SRF No. 0148483
 County Project No. 091101

**CSAH 112 – Phase 1
 Project Advisory Committee (PAC) Meeting
 June 17, 2015; 8:00 am – 10:30 am
 Orono City Hall
 MEETING RECORD**

Subject: CSAH 112 Phase 1 Final Design (Willow Drive to Wolf Pointe Trail)
Hennepin County Project No. 091101

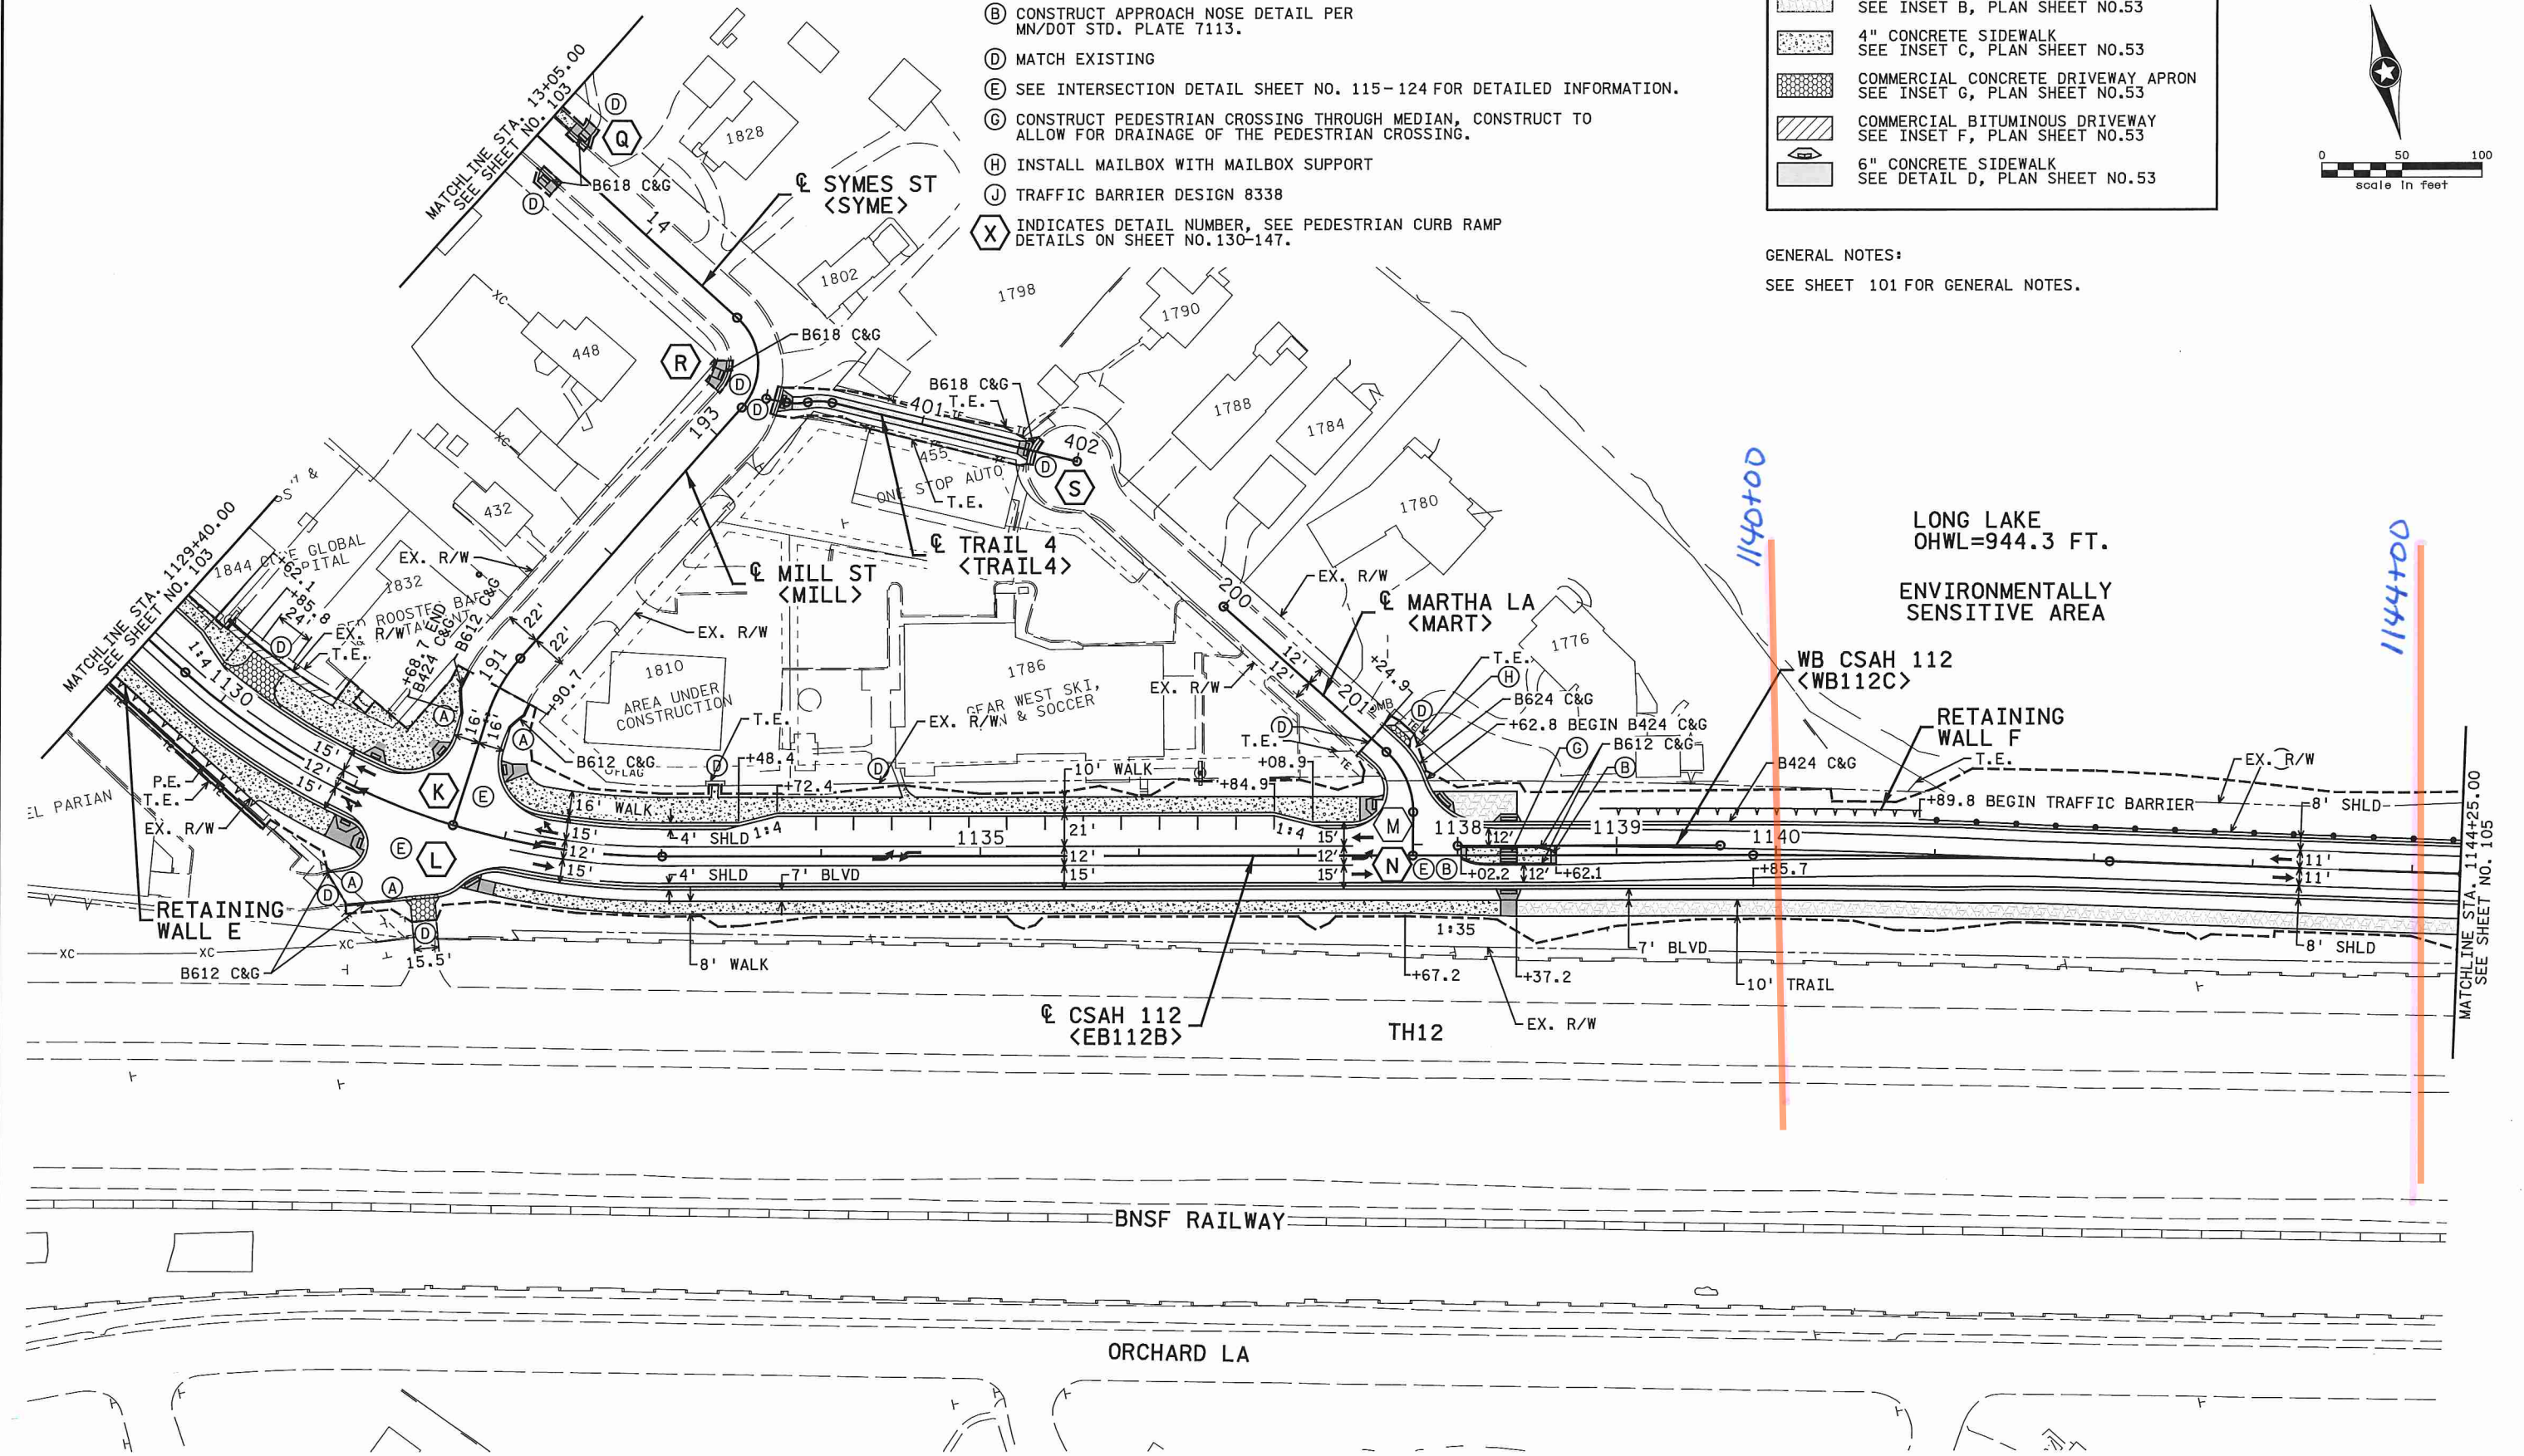
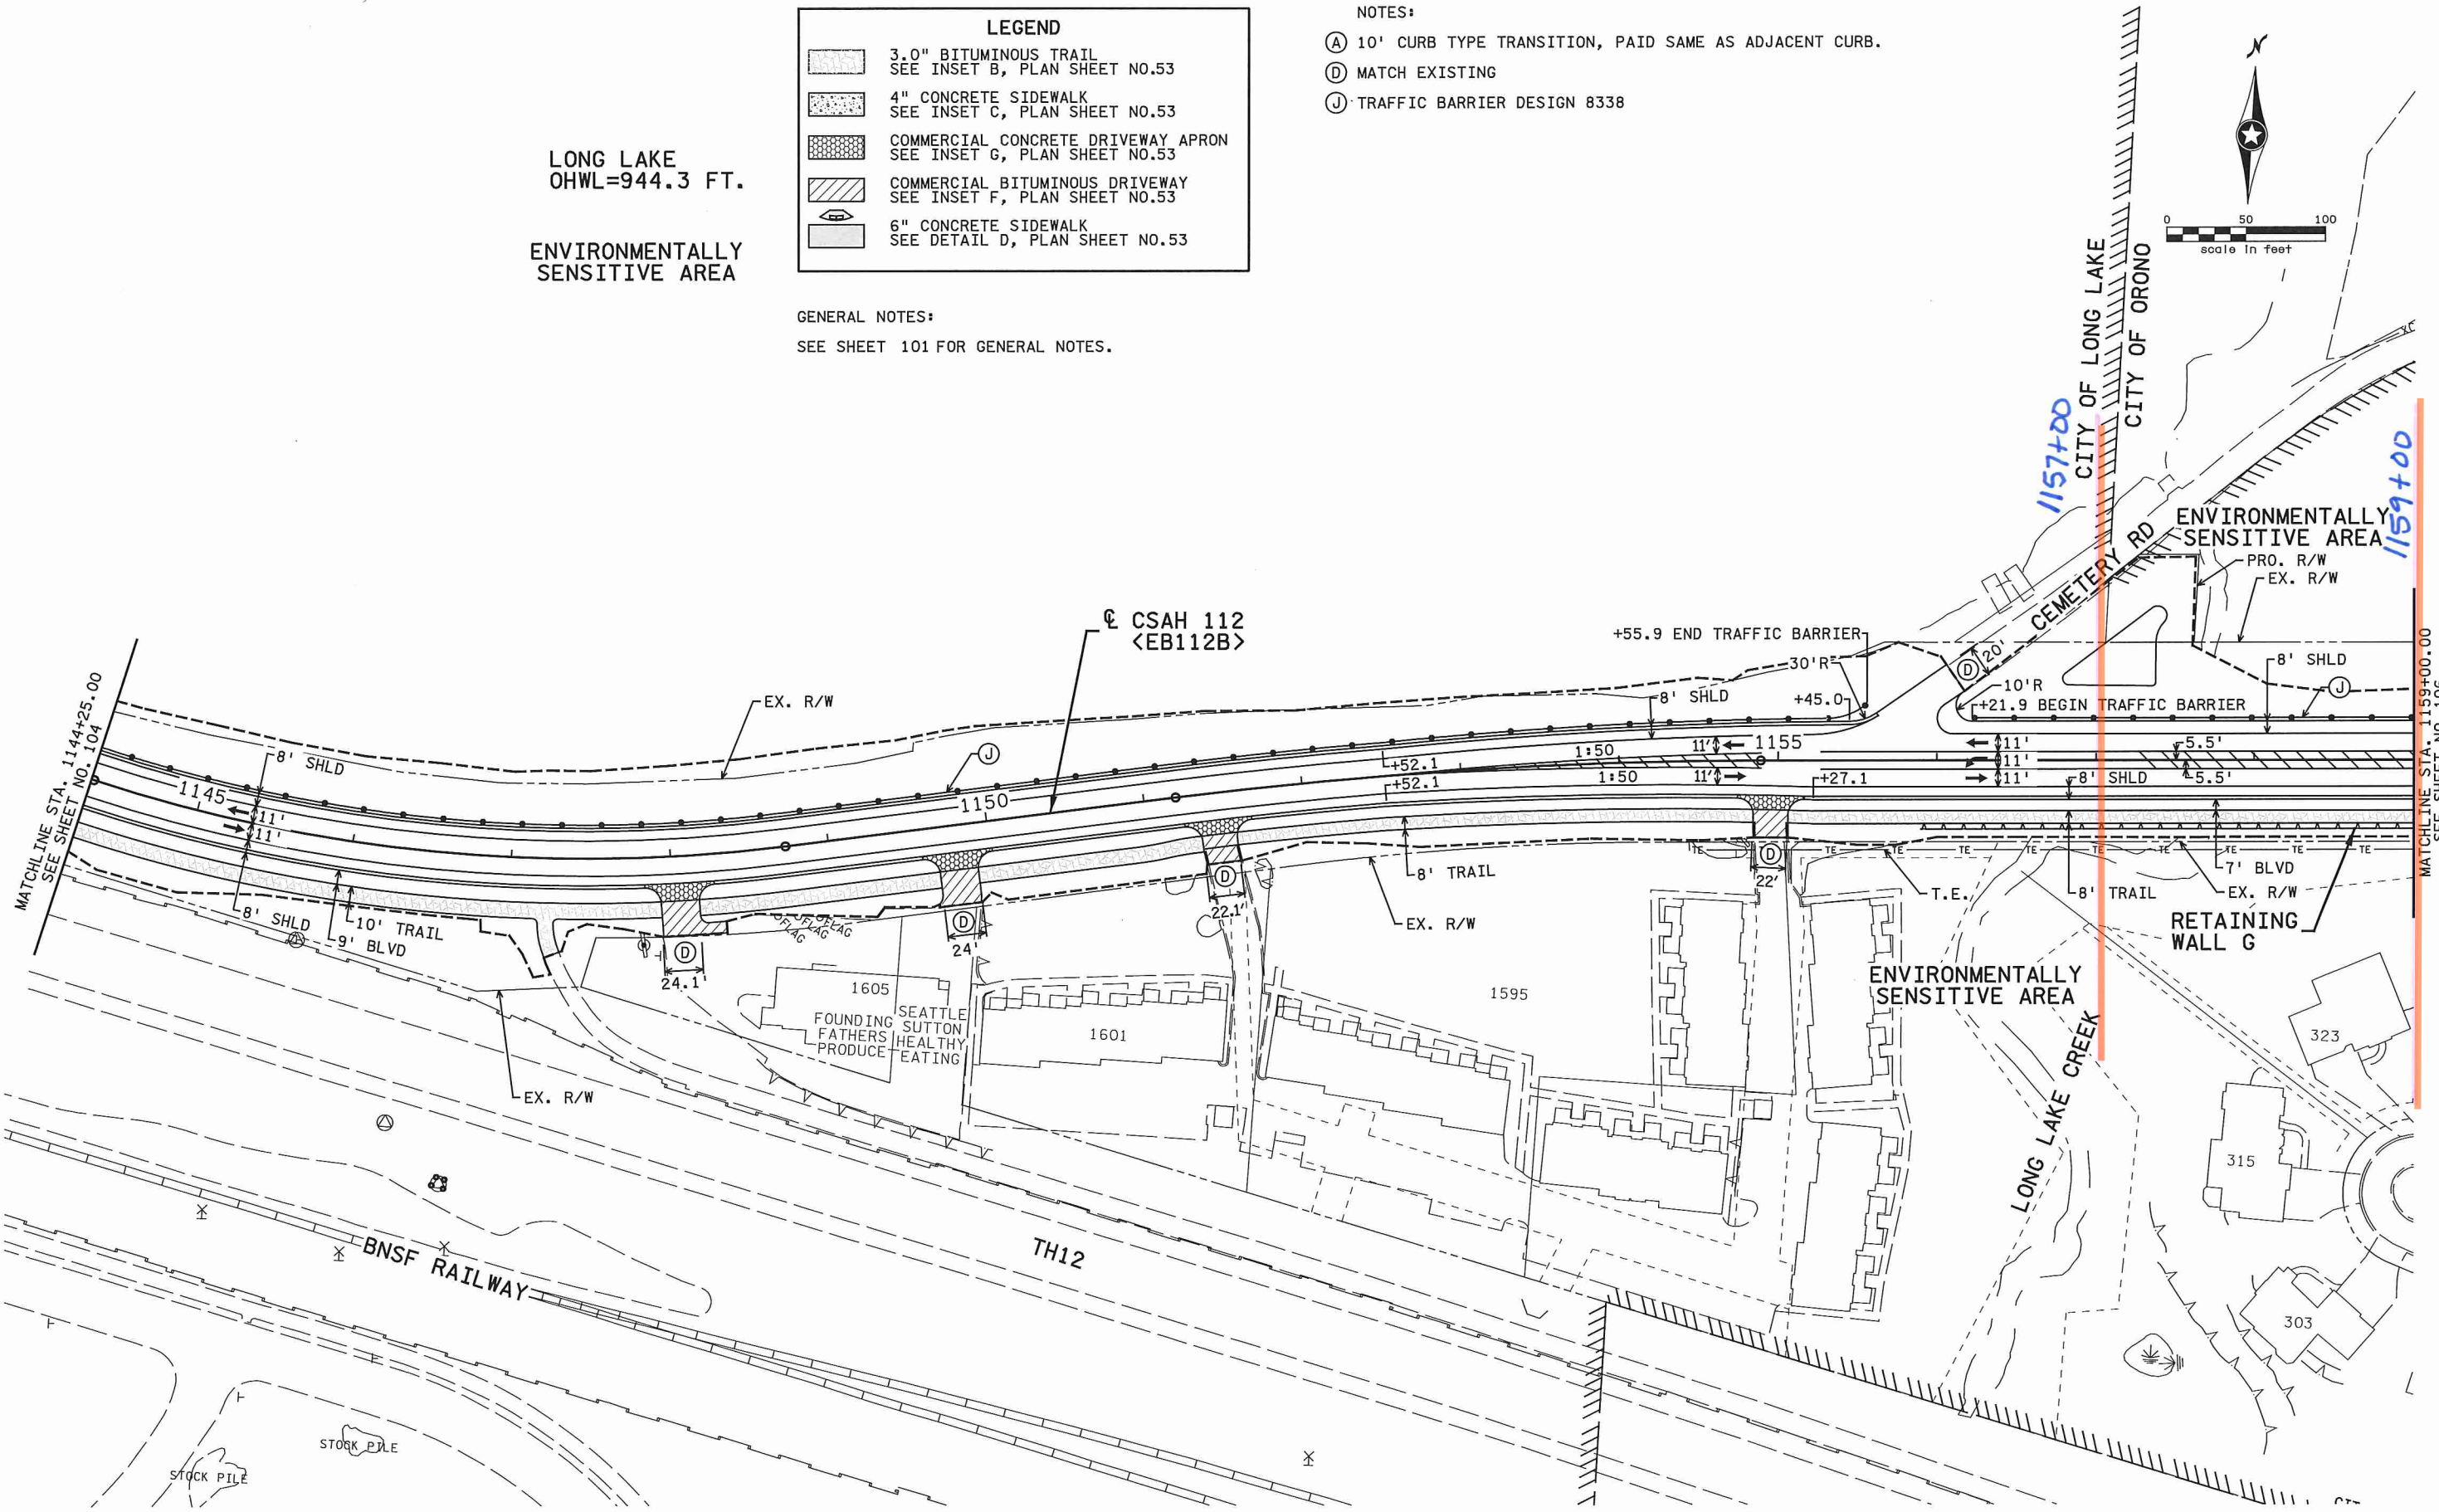
Nate described the first two plan sheets (numbered 104 & 105) which show the proposed improvements as currently designed with the trail along the south side of CSAH 112. He noted four (4) cross sections were selected, represented by the orange lines, at key locations to review the impacts. Nate mentioned one of the key items was to hold the proposed construction impacts, in the waters of Long Lake, as unchanged which requires the centerline of CSAH 112 to shift south to provide space for the trail along the lake.

Working from west to east (left to right) on sheets 104 & 105, Nate described the cross sections which are located and numbered as (Sta. 1140+00, 1144+00, 1159+00, and 1157+00) and identified with the orange lines on sheets 104 & 105.

The PAC discussed the items presented above and agreed that relocating the trail to the north side, east of Martha Lane to Wolf Pointe, was the preferred option even though it requires redesigning the eastern half of Phase 1. Some notable points mentioned for relocating the trail included:

6/3/15
15.5' Offset from current
centerline required to hold RSS
at 60% Design Location while
accommodating the trail along
north side.

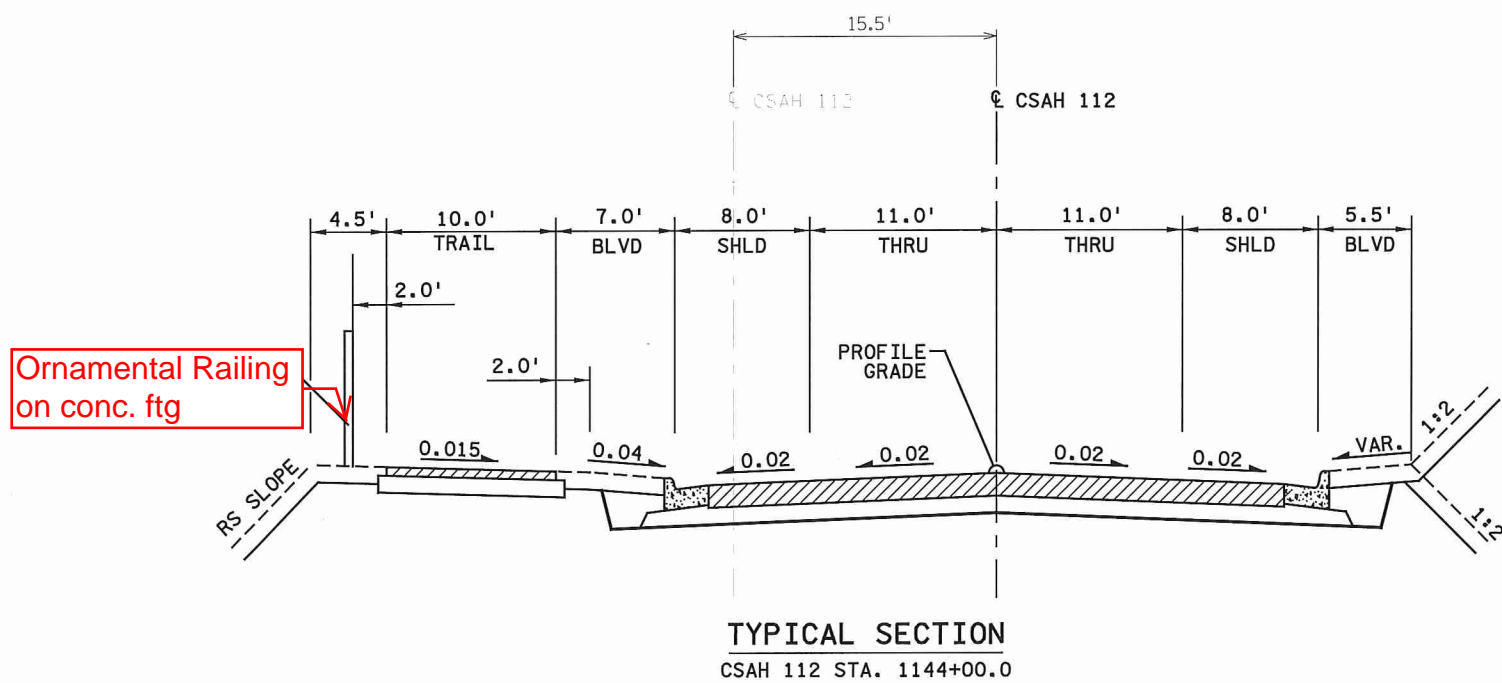
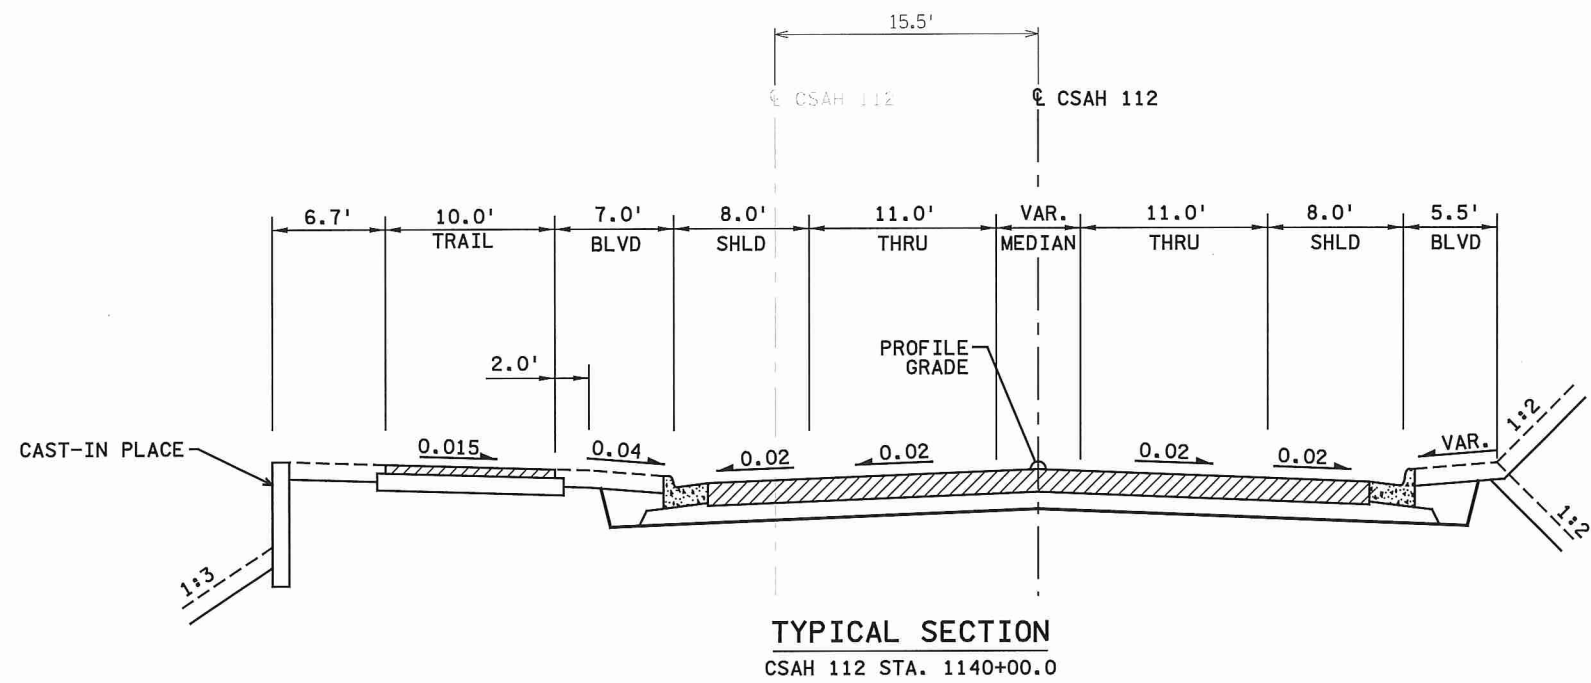
Nate noted at the west end near Martha Lane, the centerline of CSAH 112 would need to shift 15.5 feet south (Sta. 1140+00 and 1144+00), from the originally proposed centerline, in order to move the trail to the north side and hold the construction limits. Referring to these cross sections, Nate described the elements shown on the sections from left to right, with the Lake being on the left side and the existing berm / noise fence on the right side. He noted there was insufficient space along the right side (south of 112) to construct a sidewalk without potentially constructing a retaining wall.
